NORTHEAST NUCLEAR ENERGY COMPANY
THE CONNECTICUT LIGHT AND POWER COMPANY
THE WESTERN MASSACHUSETTS ELECTRIC COMPANY
DOCKET NO. 50-336
MILLSTONE NUCLEAR POWER STATION, UNIT NO. 2
AMENDMENT TO FACILITY OPERATING LICENSE

Amendment No. 94
License No. DPR-65

SAFETY EVALUATION BY THE OFFICE OF NUCLEAR REACTOR REGULATION

RELATED TO ISSUANCE OF AMENDMENT NO. 94 TO DPR-65

Figure 3.4-2
 Reactor Coolant System Pressure Temperature Limitations for 7 Full Power Years

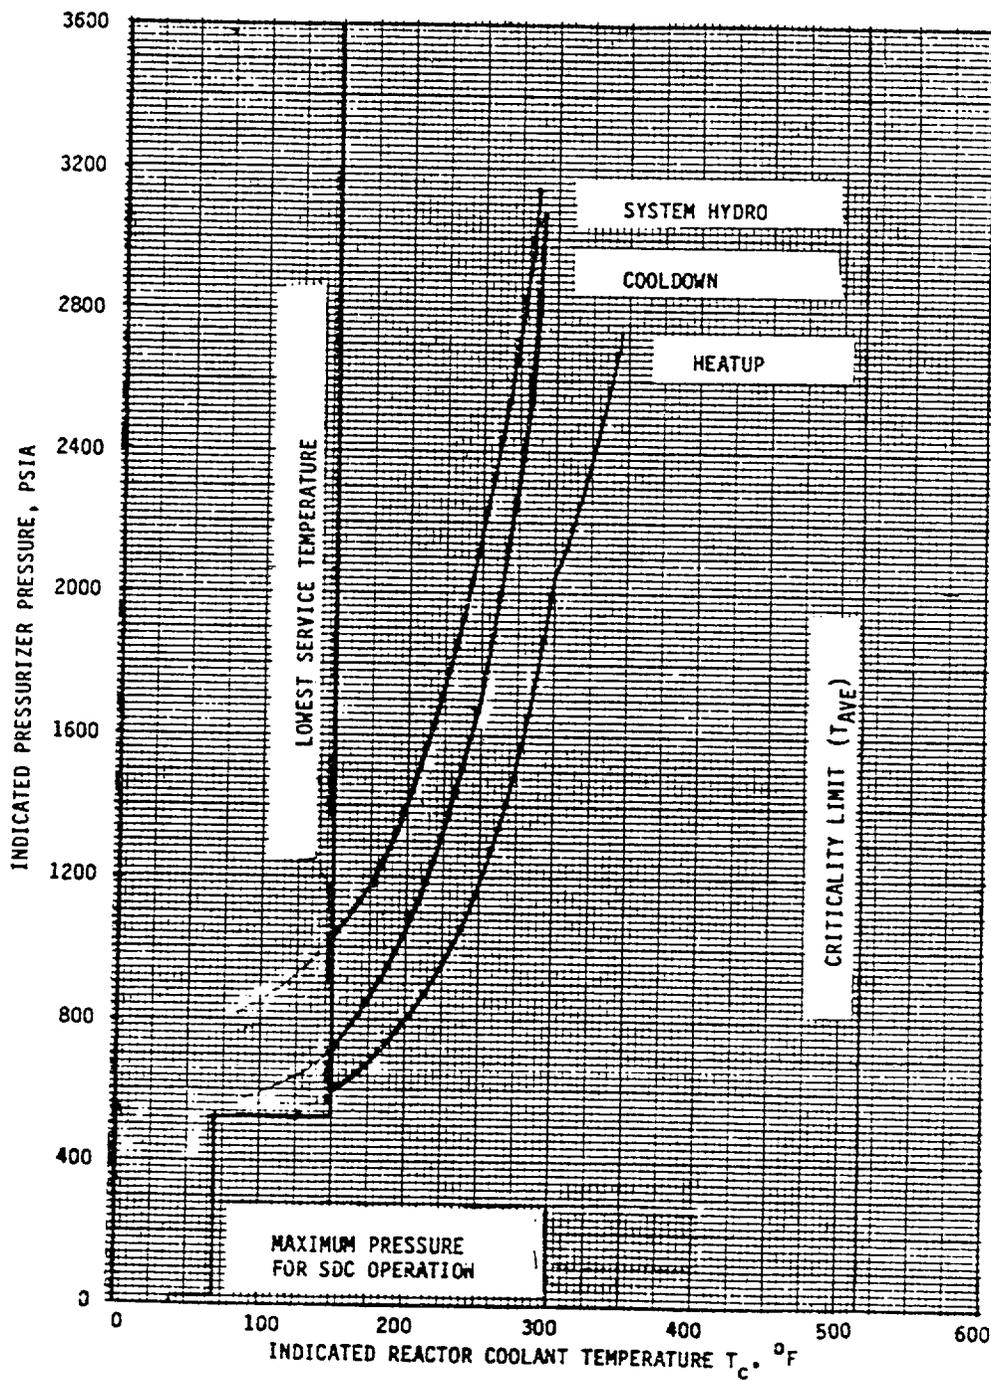
This amendment modifies the technical specifications to revise the pressure-temperature limits and the maximum rate of heatup for the reactor coolant system. In addition, the reactor vessel material irradiation specimen withdrawal schedule is revised and the technical specification bases have been updated to conform with recent changes in 10 CFR 50 Appendix G.

In a letter from W. G. Council to J. R. Miller dated January 4, 1984, the Northeast Nuclear Energy Company (NNECO) requested a revision to the Millstone Nuclear Power Station, Unit No. 2 (Millstone-2) Technical Specifications (TS). The licensee's proposed TS changes were to Section 3.4.4.9, Pressure/Temperature Limits and to Table 4.4-3 Reactor Vessel Material Irradiation Surveillance Schedule.

Based on our analysis, which indicates the licensee has used conservative values for (a) the initial RT^{NDT} of the limiting closure flange and beltline materials, (b) the ART of the limiting beltline material, and (c) the water/metal temperatures profile, we conclude that the licensee's proposed pressure-temperature limits meet the safety margins of Appendix G, 10 CFR 50, for a period of time corresponding to 7 EFPY and may be incorporated into the Millstone-2 TS.

3.4.9.1 The Reactor Coolant System (except the pressurizer) temperature and pressure shall be limited in accordance with the limit lines shown on Figure 3.4-2 during heatup, cooldown, criticality, and inservice leak and hydrostatic testing with:

- a. A maximum heatup of 40°F in any one hour period with T_{avg} at or below 200°F, 50°F in any one hour period with T_{avg} at or below 300°F and above 200°F, and 100°F in any one hour period with T_{avg} above 300°F.
- b. A maximum cooldown of 100°F in any one hour period with T_{avg} above 300°F and a maximum cooldown of 20°F in any one hour period with T_{avg} below 300°F.
- c. A maximum temperature change of 5°F in any one hour period, during hydrostatic testing operations above system design pressure.
